**Subject:** Safety Notice 658 conference call  
**Location:** Watertown - Conference Room 501 Upstairs - "GENERAL"  
**Start:** Wed 5/24/2017 9:45 AM  
**End:** Wed 5/24/2017 10:10 AM  
**Show Time As:** Tentative  
**Recurrence:** (none)  
**Meeting Status:** Not yet responded  
**Organizer:** Kolden, Les

**Vehicle Report**

# Safety Notice SN658

**GFI Circuit Breakers on 408 volt Hy-Power units**

PART NAME FOR ASSEMBLY DRAWING: 9157975  
 SHEET 1 OF 2

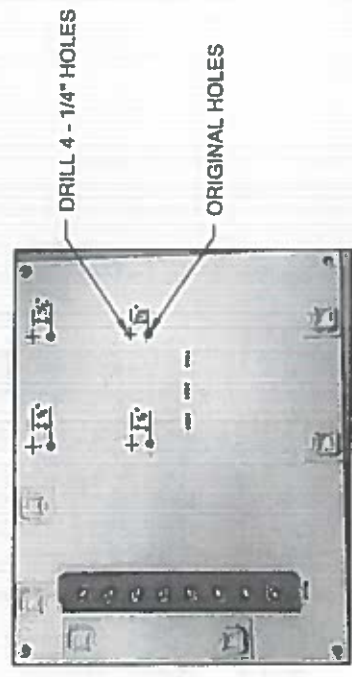
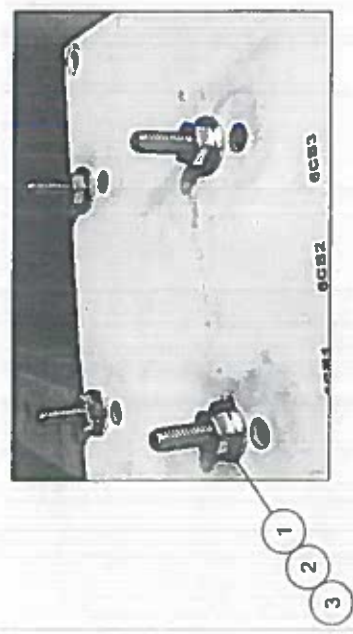
**Describe the defect/noncompliance remedy program, including the manufacturer's plan for reimbursement.**  
TSD will replace the breakers with GFCI personal protection breakers at no cost to the owner.

**Describe what distinguishes the remedy component from the recalled component.**  
The affected GFCI have the marking CBI visible through the clear breaker cover. The replacement Eaton GFCI do not have a visible manufacturers mark showing without disassembly.

1. Turn hybrid off, turn the ignition key off, disconnect charging cable if the Hypower is plugged in for charging, and push in the Hypower emergency stop.
2. Remove the cover of the export power box. Disconnect all wiring and remove plate with breakers and grounding bar.

3. Remove breakers from DIN rail and remove DIN rail. Drill 4 - 1/4" holes 1/2" up from the original DIN rail mounting holes.

4. Install 1/4-20UNC X 1.00" long bolts with a washer and nut. The nut and washer are used to position the DIN rail to the correct height.
